Subject: Central Relief Drain CSO In-line Storage, Green Infrastructure, and Distributed Storage
New Project
DOJ Case No. 90-5-1-1-08254

Subject: Central Relief Drain CSO In-line Storage, Green Infrastructure, and Distributed Storage
New Project
DOJ Case No. 90-5-1-1-08254

Project Name: Central Relief Drain CSO In-line Storage, Green Infrastructure & Distributed Storage

Central Relief Drain CSO Service Area

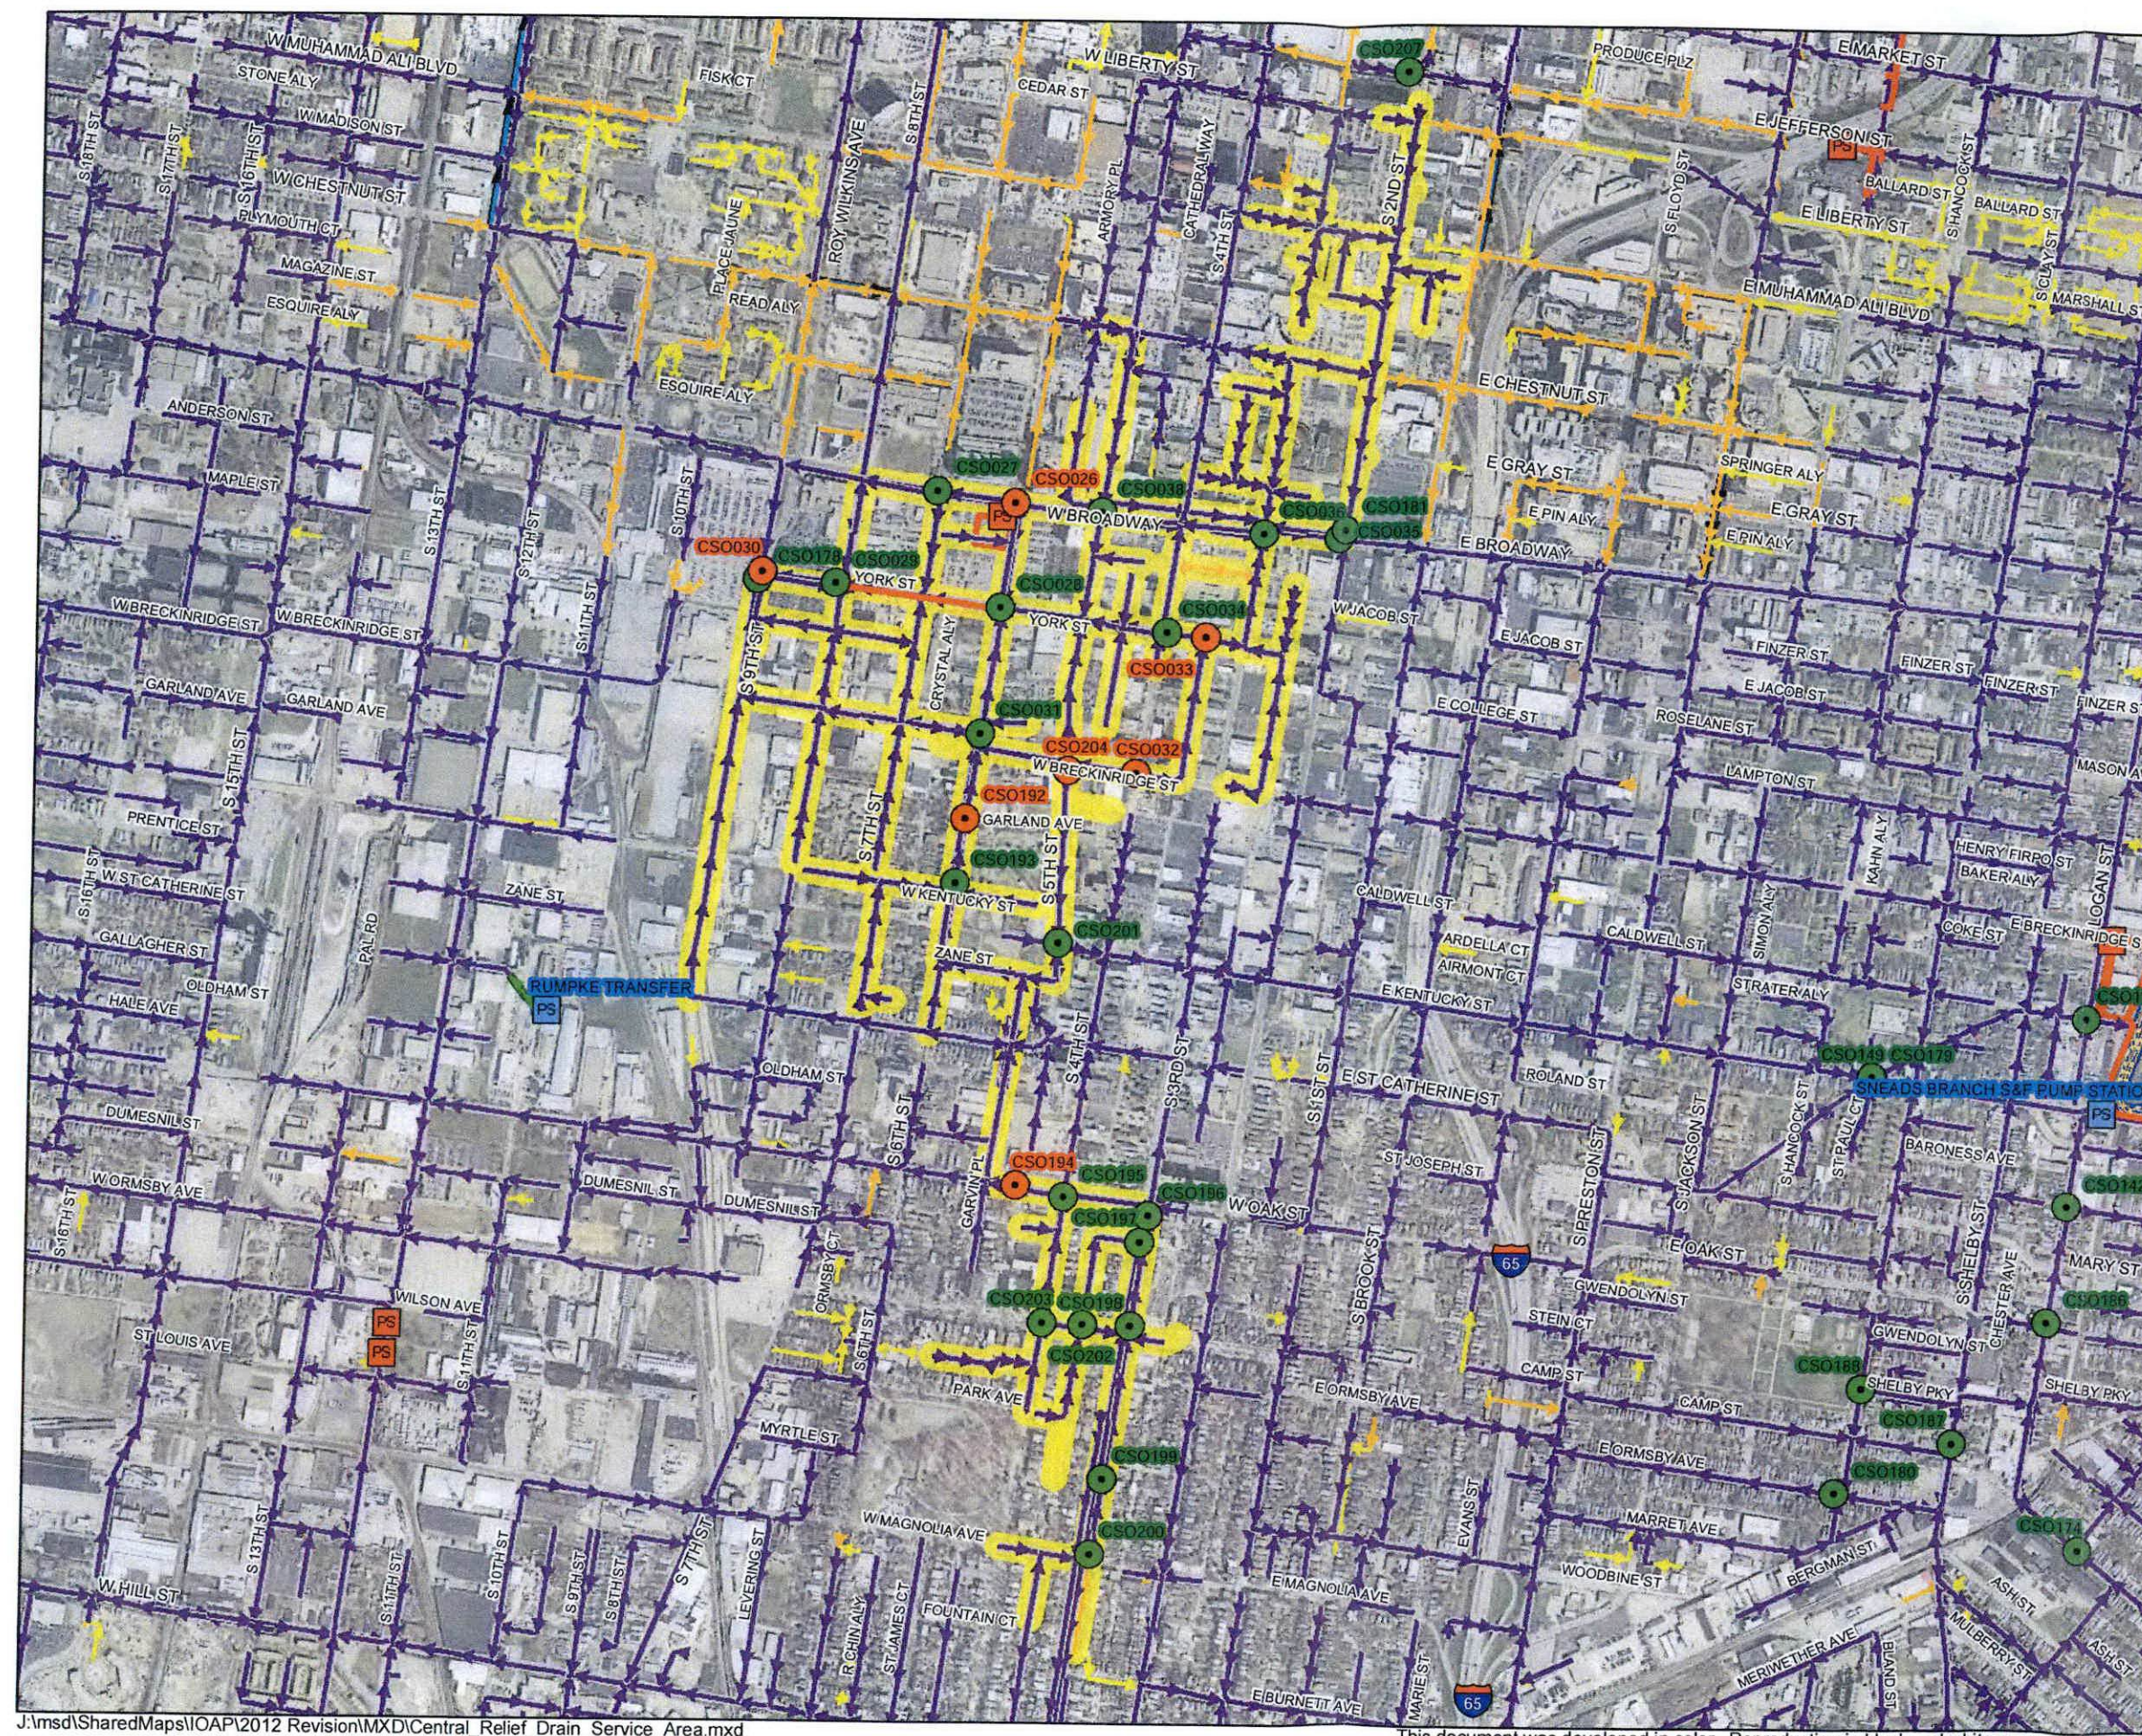
Project Description: Weir raises on existing CSO structures to reduce overflows to 8 per typical year. CSO 200 is diverted to the east into the Sneads Branch Relief. Additional Green Infrastructure is accounted for in cost to reduce runoff to offset potential flooding concerns at viaducts. Bending weirs may also be used in lieu of traditional static weirs.

Design Assumption: Assumes weir raises will be acceptable. Additional evaluating of potential flooding at weir raise level will need to be evaluated based on the configuration of each CSO structure. Green Infrastructure or bending weirs may be used to mitigate potential increase of flooding risks.
